UNITED STATES DISTRICT COURT  
SOUTHERN DISTRICT OF NEW YORK

**NEW YORK SMSA LIMITED PARTNERSHIP  
d/b/a VERIZON WIRELESS, and HOMELAND  
TOWERS, LLC,**

**EXPERT REBUTTAL REPORT OF BONNIE FRANSON, AICP CEP, PP**

DRAWN: PD    APPROVED: JS  
 SCALE: AS SHOWN  
 DATE: 12/19/2017  
 PROJECT NO: 16237  
 DWS:    PAR:    SDR:    3, GRAD-UTIL-SE  
 1837-D    SECTION A  
 DRAWING NO: **ZD-13**

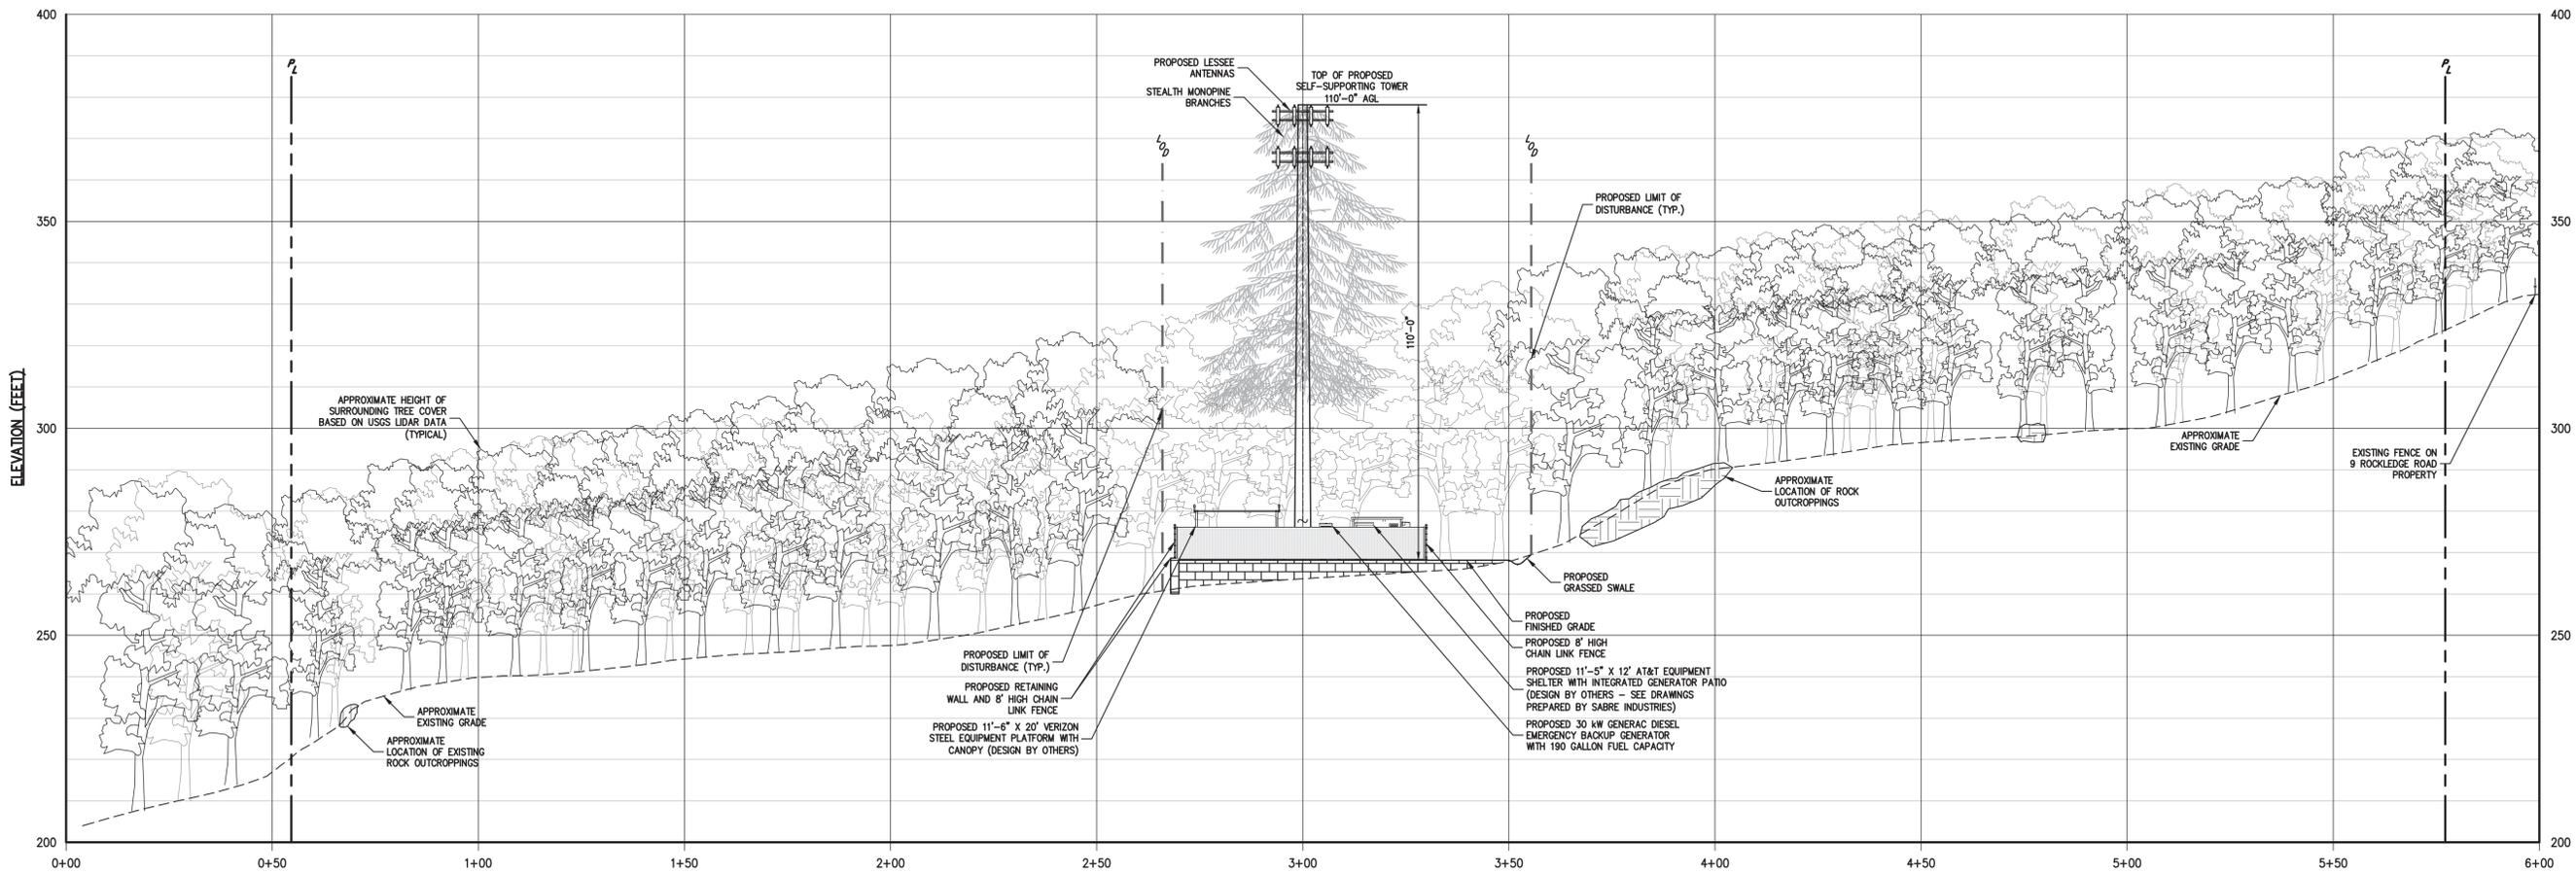
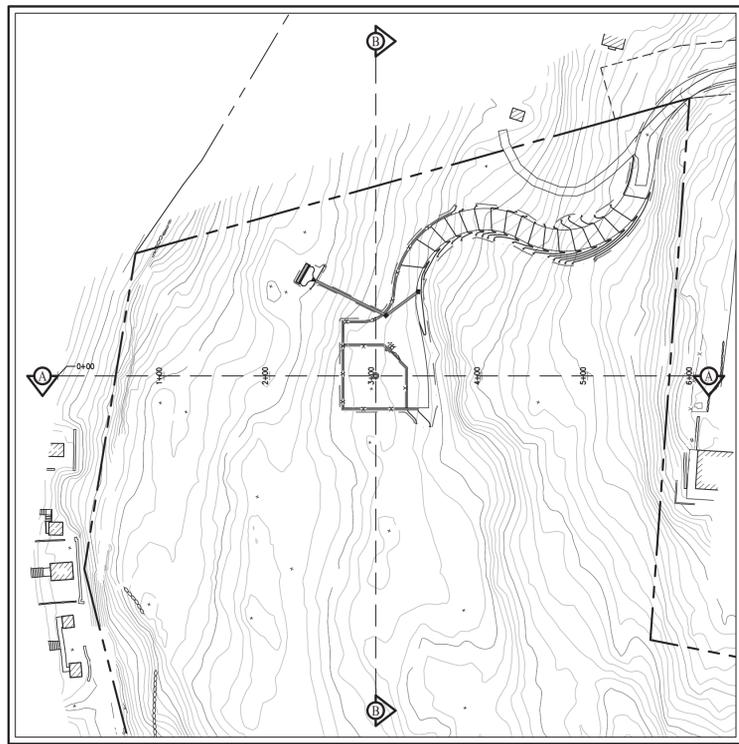
that are 55 feet in front of the tower as represented on the site plan, will result in 60 feet of the tower being visible. The simulated branches of the tower will only cover 40 feet of the tower extending above the tree line, leaving the monopole uncamouflaged and exposed.

32. Based on the Sabre Industries design, the branching will not extend below the tree line and the monopole will be visible above the tree line. Further, ZD-13 and ZD-14 misrepresent the branch length of the proposed monopine – the maximum length of the branch is 14 feet – see also **Exhibit V-3. Exhibit V-4**, by editing the site plan cross section and removing the branching below 70 feet AGL and branching beyond 14 feet, illustrates a significantly less camouflaged tower which is what the Plaintiff proposed to construct. In conclusion, the site plan and Visual Resource Assessments submitted to the ZBA as well as the SHPO for review completely misrepresent the visual appearance of the proposed tower, and thus fail to accurately document the significant visual adverse impact the tower will have on the adjoining National Register-eligible Cemetery and the significant scenic and historic landscape within which the tower is to be located.

Photo source: Saratoga Associates VRA – VP11:  
Cold Spring Cemetery (near historic Gatehouse) – "Figure 5b"

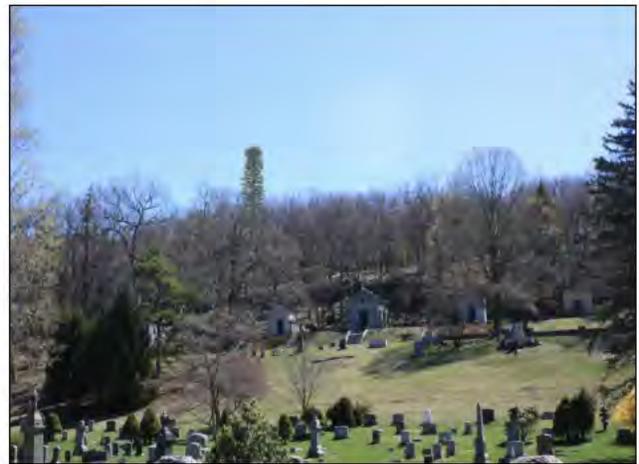
“In fact, deciduous woodlands provide a substantial visual barrier in all seasons. **Since the digitized forest cover overlay generally identifies only larger stands of woodland vegetation that is clearly distinguishable from aerial photography, the land cover viewshed map is substantially representative of both leaf-on and leaf-off seasons...**

Photo source: Saratoga Associates VRA – VP12:  
Cold Spring Cemetery (north end) – “Figure A7”

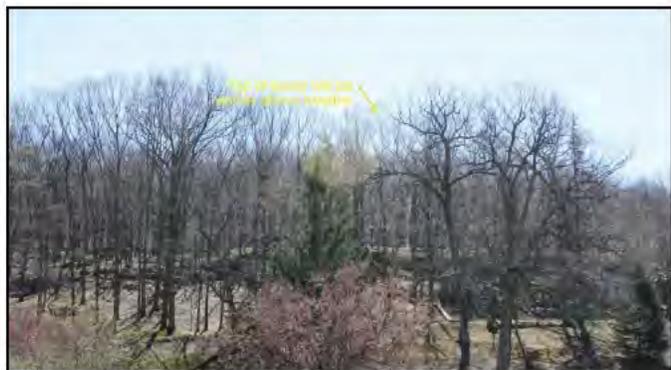
- The VRA's photo simulations provide representations of the cemetery from the two identified vantage points of the viewshed analysis. However, by simply providing two main photos with only one demonstrating an actual rendering of the proposed tower, the minimum requirements to complete a VRA for the simulation/visualization section *might* be satisfied, but additional renderings would most likely need to be submitted in order to appease the obligation of providing sufficient evidence of minimal impact.
